Access Compliance Report

Public Rights-of-Way

Intersection ID: 52919	Main Street: HOOVER_CREEK_BV	Cross Street: WALKER_BRANCH_DR	Location: E
ADA ID: 55ECBF136A81	Ramp Type: PerpDiag	Initial Pass/Fail: Fail	Overall Compliance: No
Severity Score: 8.75			
Codes/Mitigation Info/Possible Solution		Field Measurements/Component Compliance

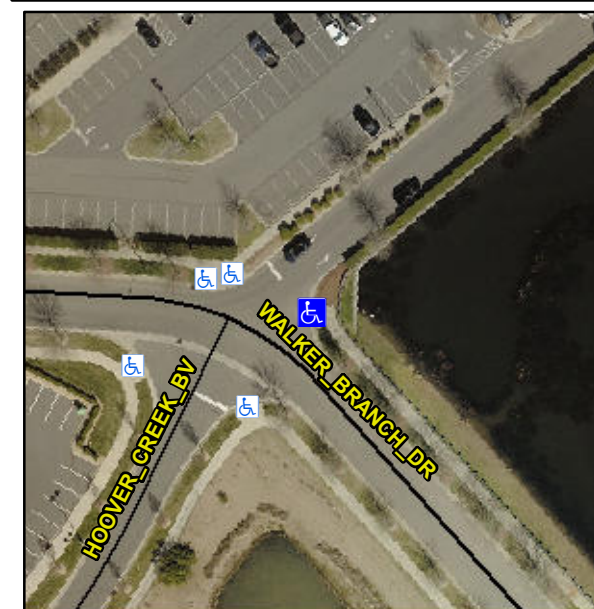
Not Found, R304.5.1

Compliance	Description	Data	Compliance	Description	Data
N/A	Ramp Length (in)	71.0	Yes	Ramp Slope (%)	5.8
No	Ramp Width (in)	46.5	Yes	Ramp XSlope (%)	0.9
N/A	Flare Type LT	N/A	N/A	Flare Type RT	N/A
N/A	Flare Slope LT (%)	N/A	N/A	Flare Slope RT (%)	N/A
N/A	Flare Traversable LT?	N/A	N/A	Flare Traversable RT?	N/A
N/A	Landing Length (in)	N/A	N/A	DWS Provided?	N/A
N/A	Landing Width (in)	N/A	N/A	DWS Contrast?	N/A
N/A	Landing Slope (%)	N/A	N/A	DWS Length (in)	N/A
N/A	Landing X Slope (%)	N/A	N/A	DWS Full Width?	N/A
N/A	Landing Curb? (Y/N)	N/A	N/A	DWS Offset (in)	N/A
N/A	Shared Landing?	N/A			
N/A	Gutter Ponding?	N/A	N/A	Gutter Slope (%)	N/A
N/A	Gutter Lip Ht (in)	N/A	N/A	Gutter X Slope (%)	N/A
N/A	Painted X Walk1?	No	N/A	Painted X Walk2?	No
	X Walk 1 Direction	To NW		X Walk 2 Direction	To SW
N/A	X Walk 1 Width (in)	N/A	N/A	X Walk 2 Width (in)	N/A
	X Walk 1 Slope (%)	2.1		X Walk 2 Slope (%)	0.0
	X Walk 1 X Slope (%)	2.7		X Walk 2 X Slope (%)	4.0

Remove & Replace Curb Ramp With Two New Directional Ramps or Equivalent.
